# United Consultants, Inc.

**Re: 70, 72, 88 and 94 East Central Street  
Site Plan and Special Permit Application Peer Review**

**Re: 70, 72, 88, and 94 East Central Street  
Site Plan Peer Review Update**

DATE	MAR. 4, 2020
SCALE	1" = 100'
PROJECT	UC1334
SHEET	1 of 9

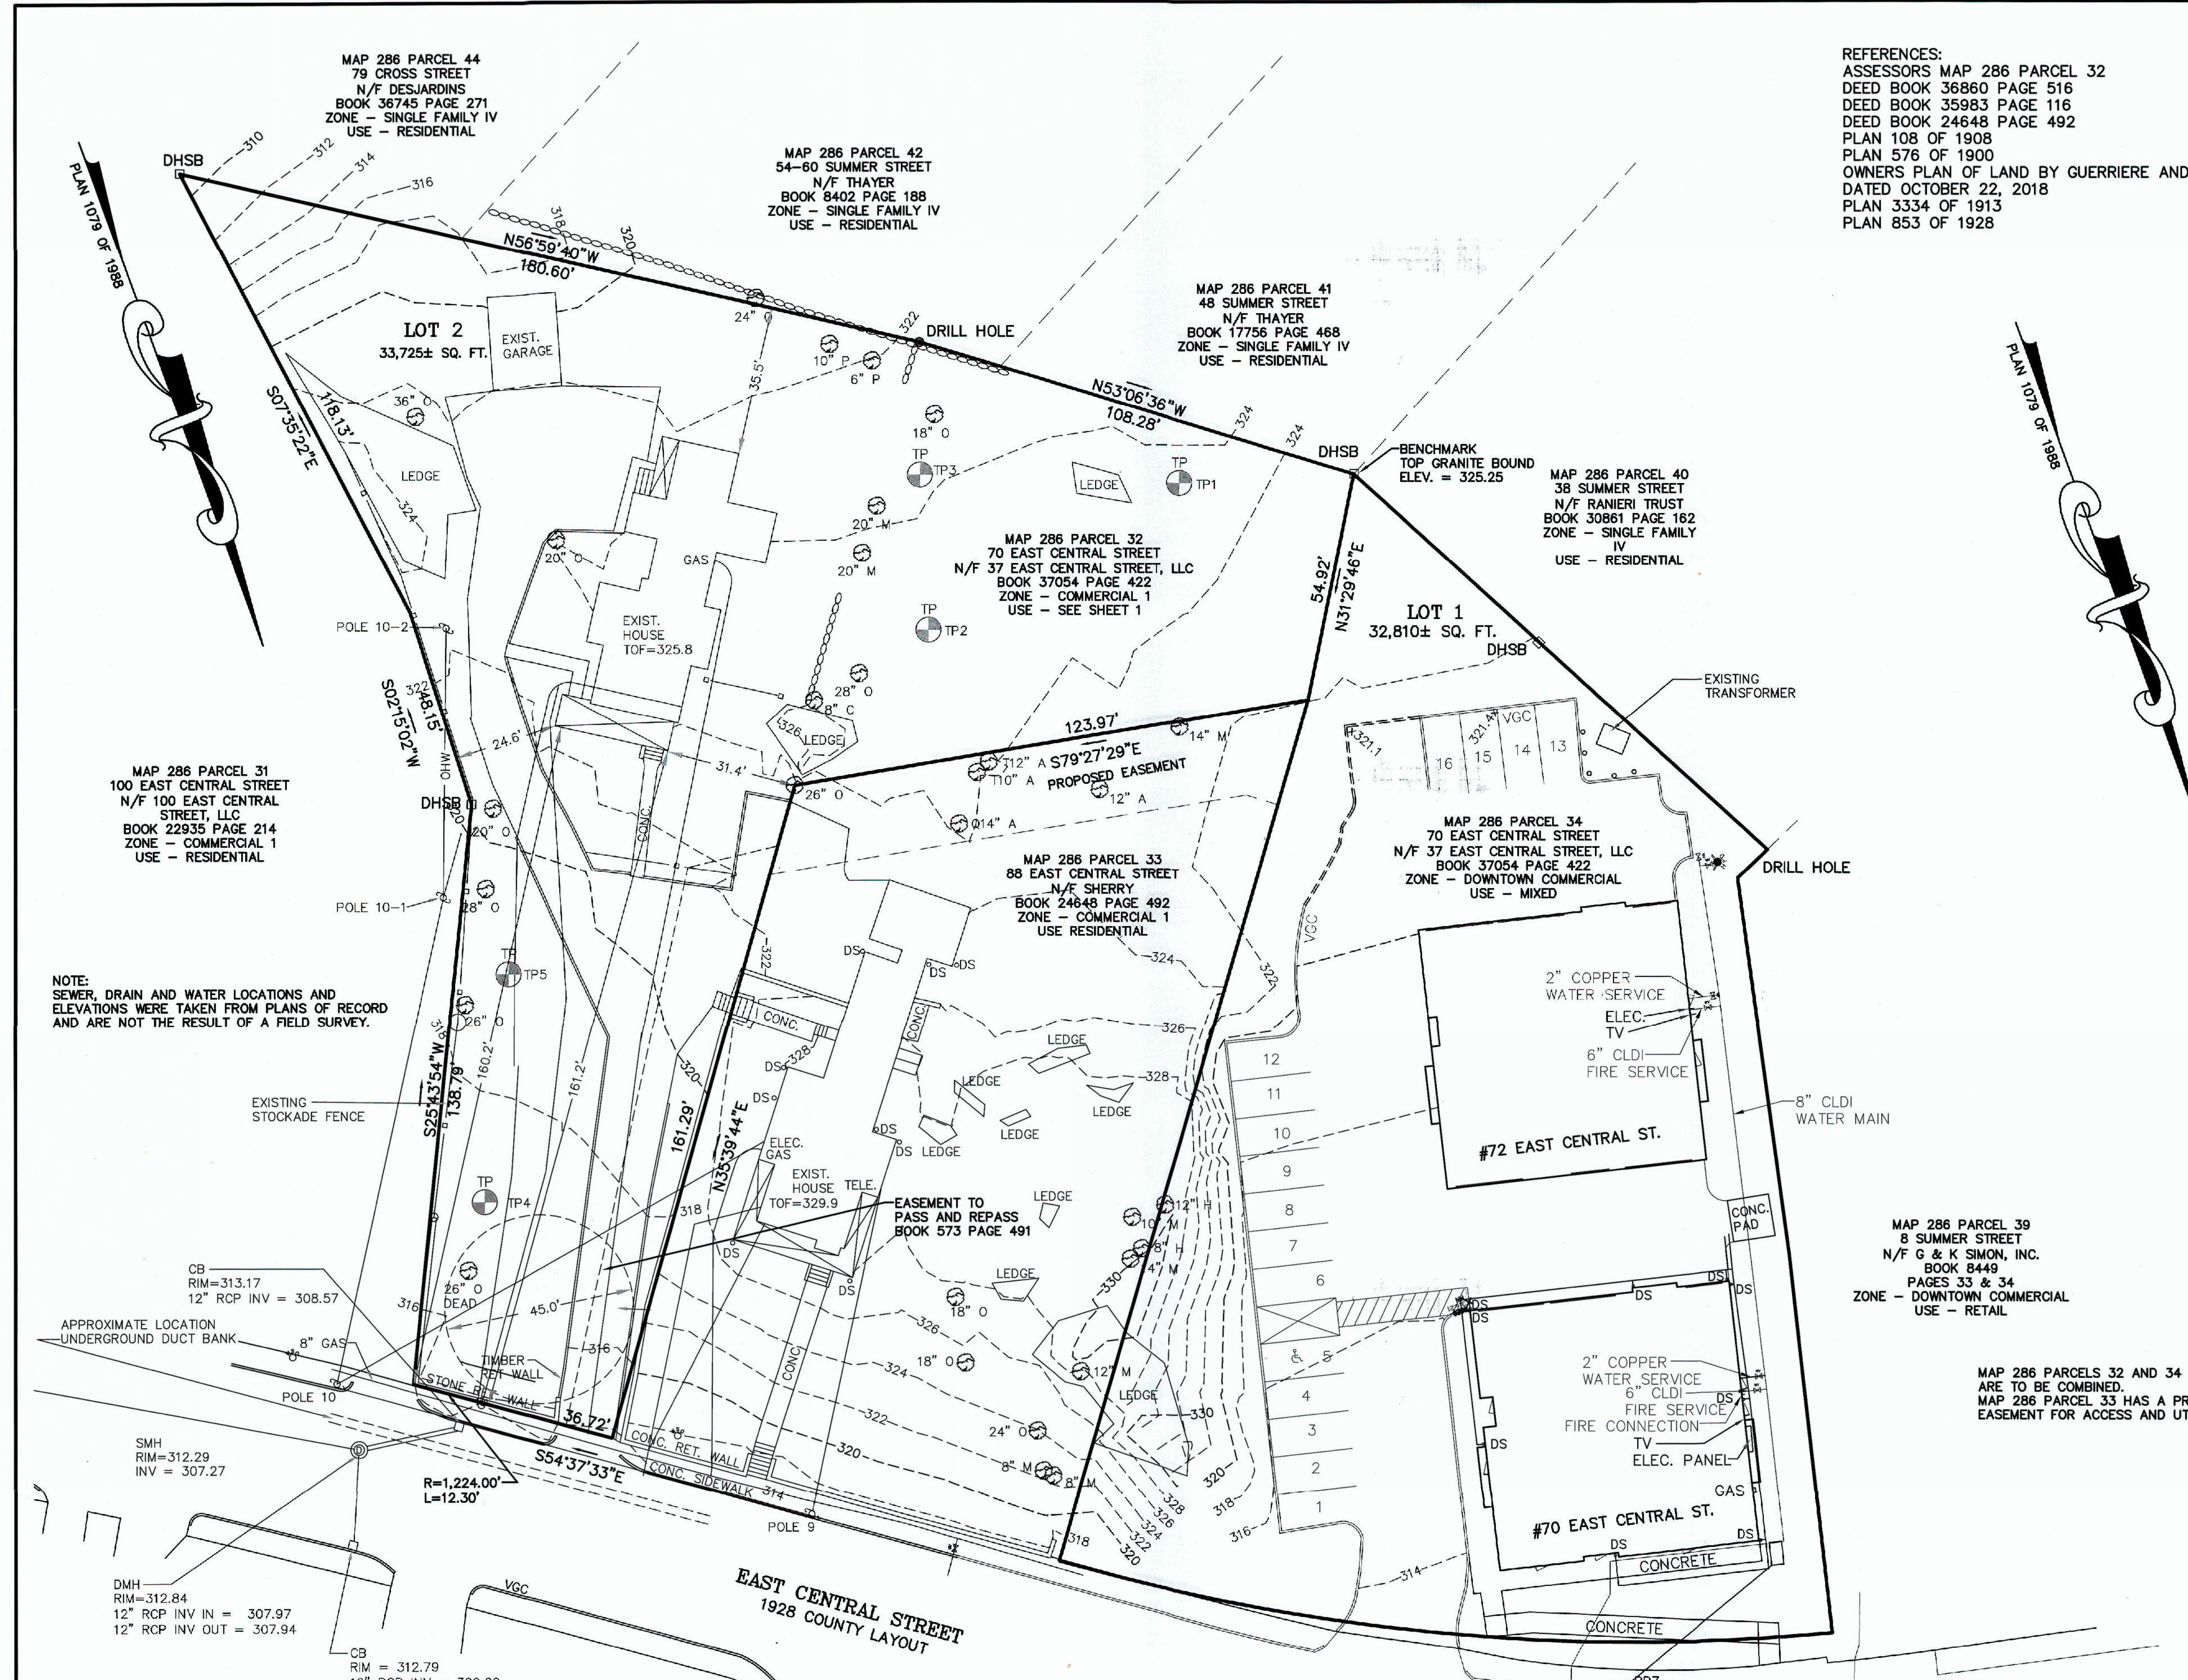
DR1. Revise lighting to eliminate spillage over the property line in the area of the 54-60 Summer Street property. Minor spillage is also anticipated along the easterly property line.

- SCH3. Revise the Zoning Table and notes on Sheet 1 to clearly reflect the current proposal. A note indicates that Map 286 Parcels 32 and 34 (#70/#72 and #94 East Central St. properties, respectively) are to be combined; however, it appears that Map 286 Parcel 33 (#88) is also to be included in the combination. Similarly, the note near the top of the Zoning Table indicates it is for the Commercial I district (#88 and #94), while the table includes the area and frontage for the parcel located in the Downtown Commercial District (#70/#72). The height requirements should be relocated to the section of the table applicable to the #88 and #94 lots.

SW2. Revise the waiver request on the cover sheet to include the proposed PVC pipe associated with the roof leaders at the rear of the site. BETA notes the Board may require the roof leader to transition to RCP as it crosses the driveway.

*Applicant to provide revised site lighting plan. Added waiver request. Sheet 1.*

*The note has been removed. Sheet 1.*

*The zoning table has been revised to provide the zoning information for 70-72 East Central Street and the proposed 88 and 94 East Central Street sites after property line adjustments.*

*The suggested waiver has been provided. Waiver request 2 sheet 1. The drain pipe material at the rear of the building has been revised to RCP.*

DATE
MAR. 4, 2020
SCALE
1" = 20'
PROJECT
UC1334
SHEET
2 of 9

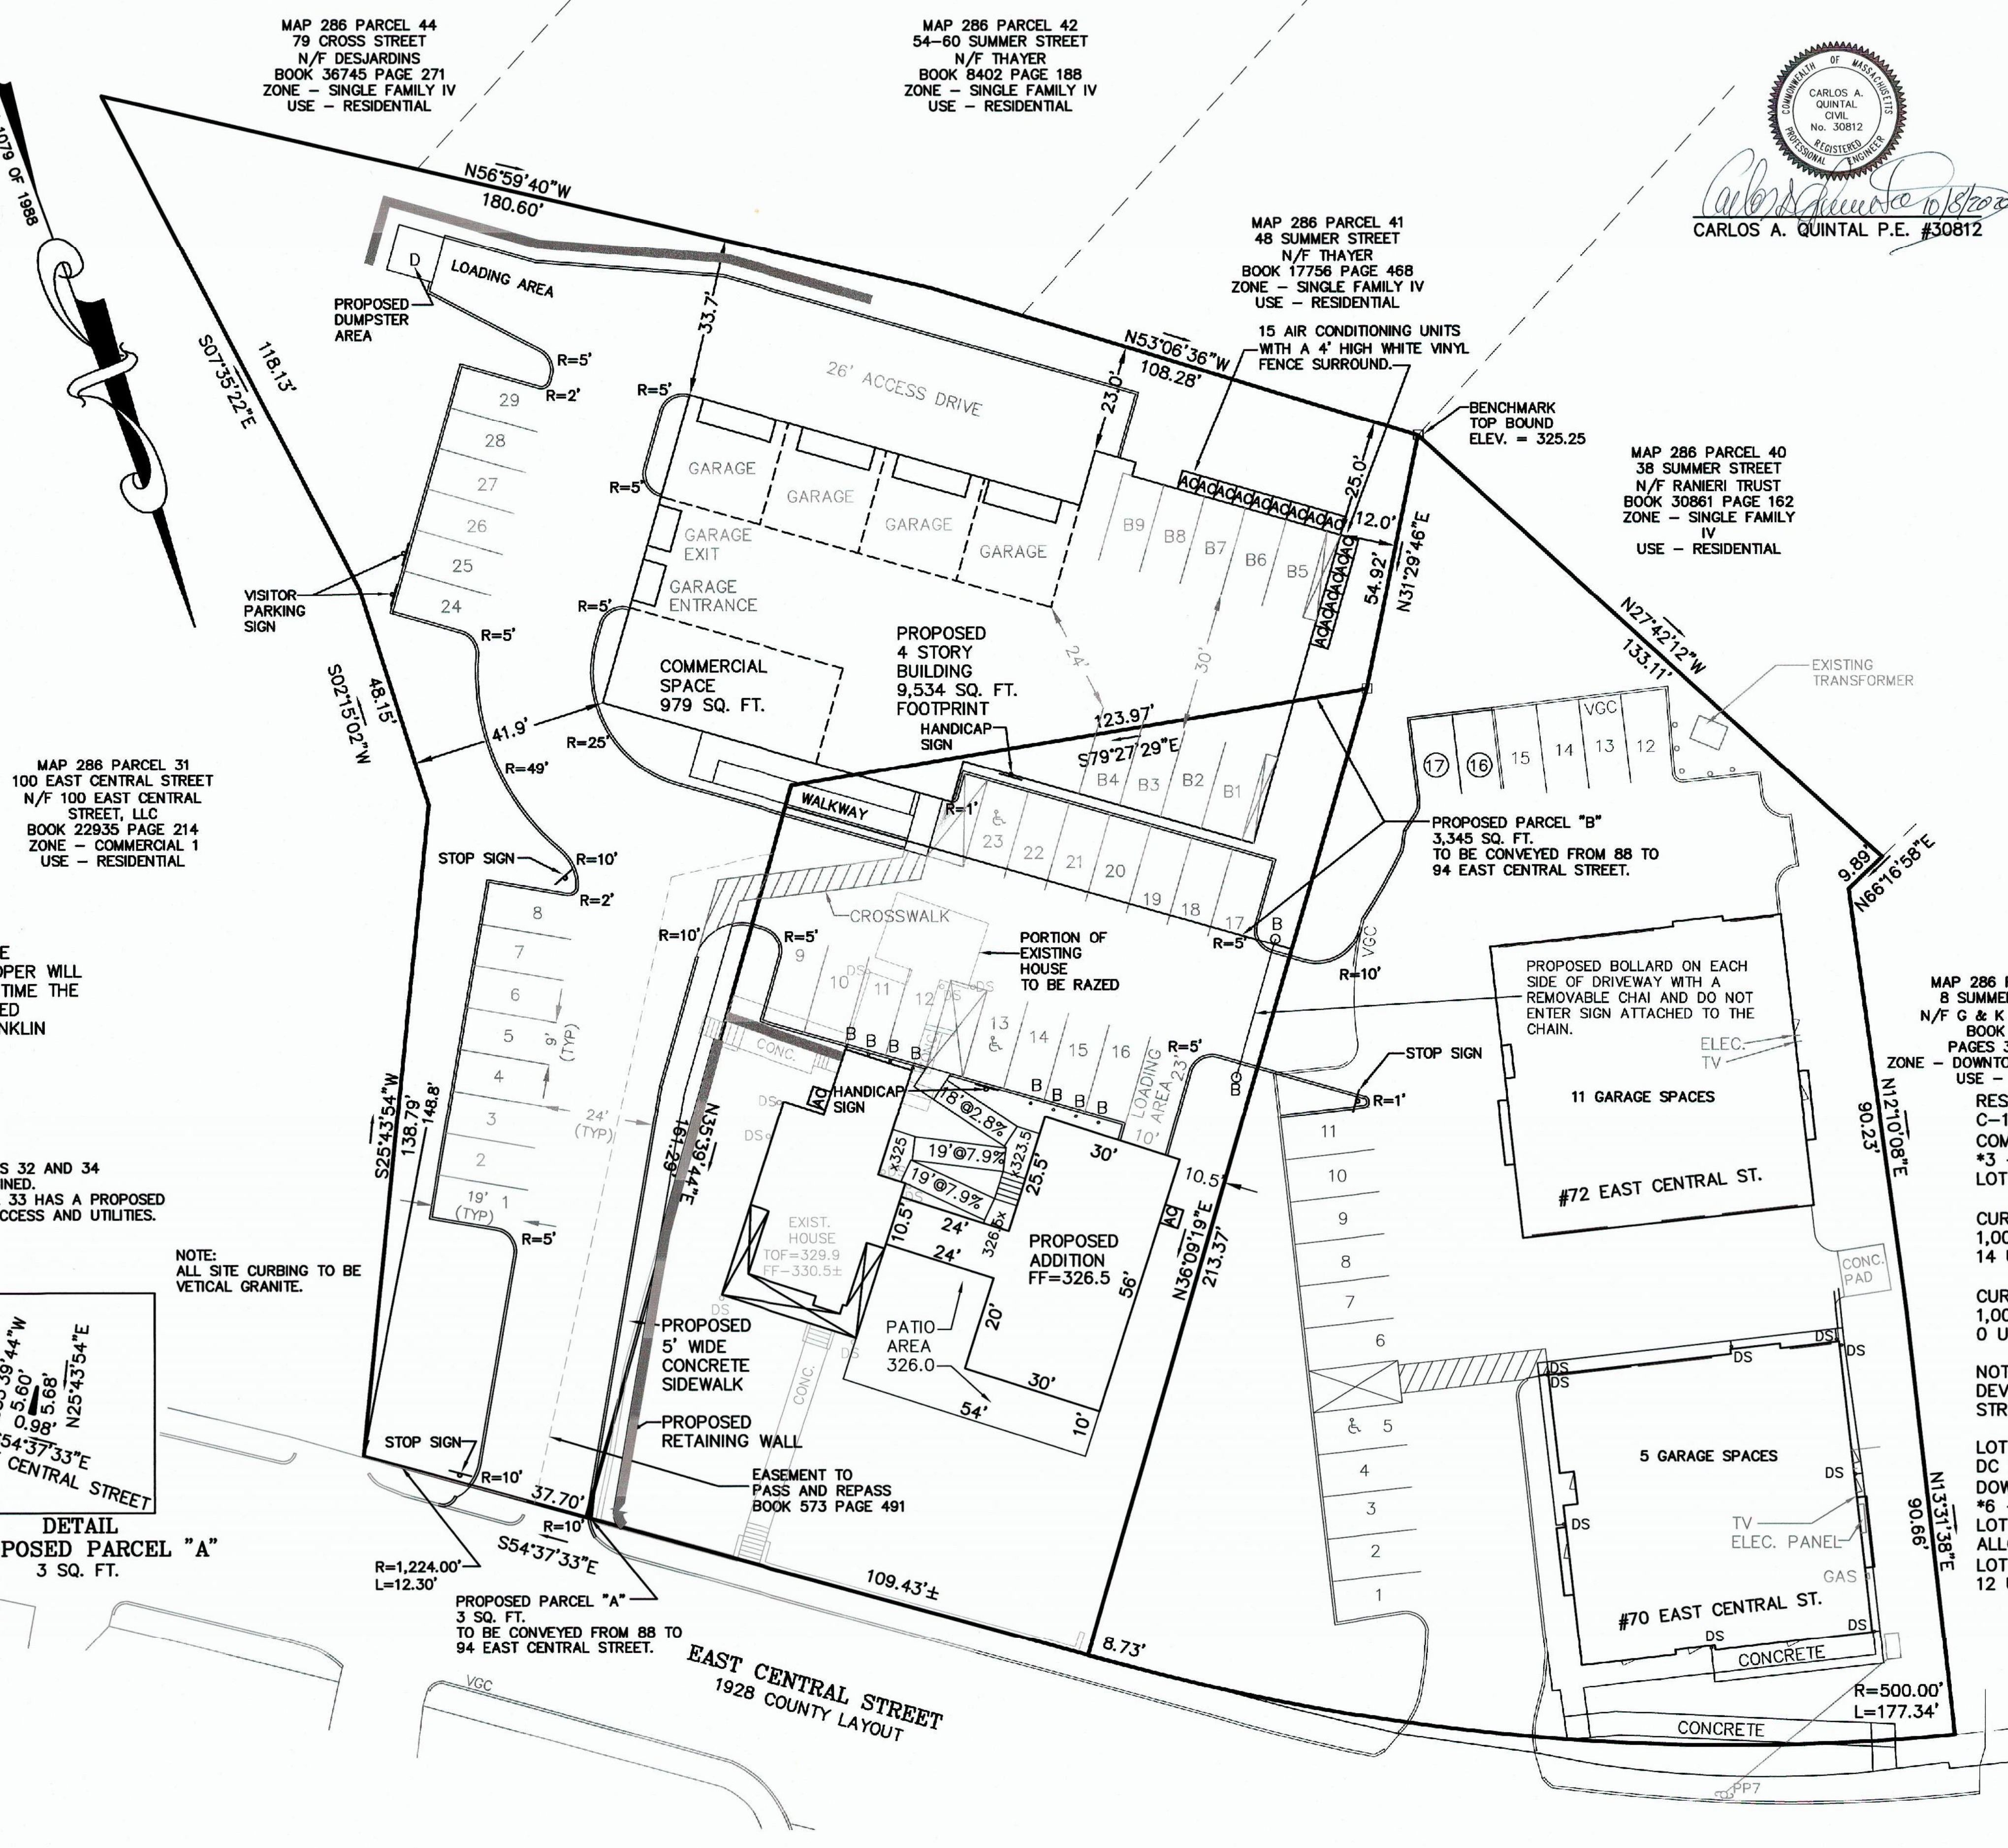
- SCH1. Clarify if the proposed easement (Sheet 2) on Lot 286-33 is still required.

*It is anticipated that the existing easement will be no longer be necessary once the lots are combined.*
